# CITY OF PORTLAND, MAINE

## PLANNING BOARD

February 3<sup>rd</sup>, 2014

**Project Name:** “118 on Munjoy Hill” Condominium  
12 unit residential, and 2 unit commercial, condominium  
**Project ID:** #2013-255  
**Project Address:** 118 Congress Street  
**CBL:** 16-D-2  
**Applicant:** Ed Theriault, EMT, LLC (118 Condominiums, LLC)  
**Planner:** Jean Fraser

1 | PARKING LEVEL | PROJECT FOOTPRINT: 8,884 GSF

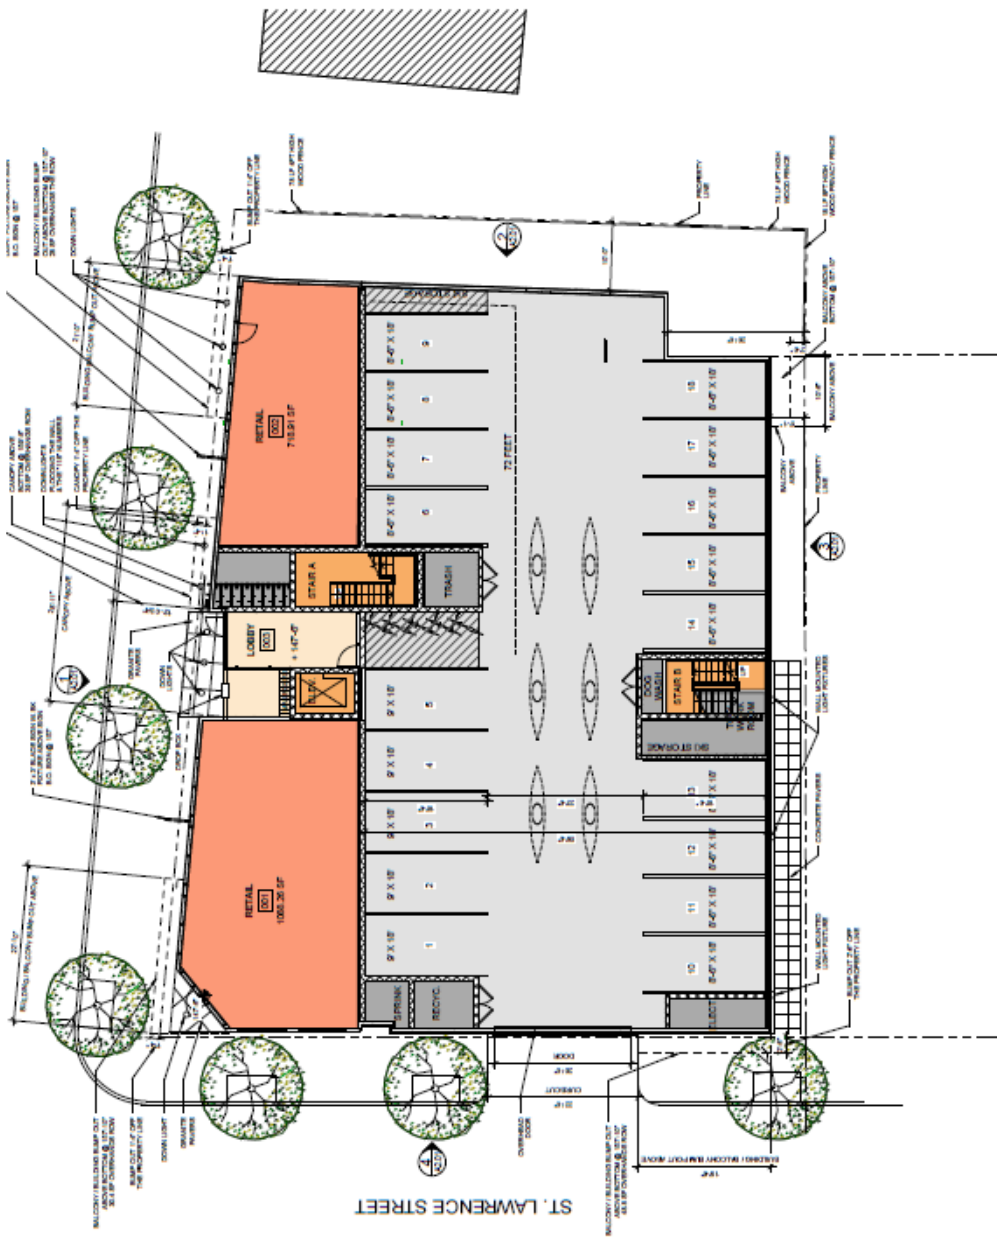
1. The Planning Board voted 7-0 to waive the Technical Design Standard Section 1.14 *Parking Lot and Parking Space Design* to allow for 13 of the indoor parking spaces to measure 18 feet by 8’6”.
2. The Planning Board voted 7-0 to waive the Technical Design Standard Section 1.14 *Parking Lot and Parking Space Design* to allow a drive aisle of less than 24 feet, as shown on Plan P12.

**Status: In addition to the request for a parking stall dimension waiver, the applicant is also requesting a waiver for a reduction in parking aisle width from 24 feet to 23 feet. I support waivers from these City standards.**
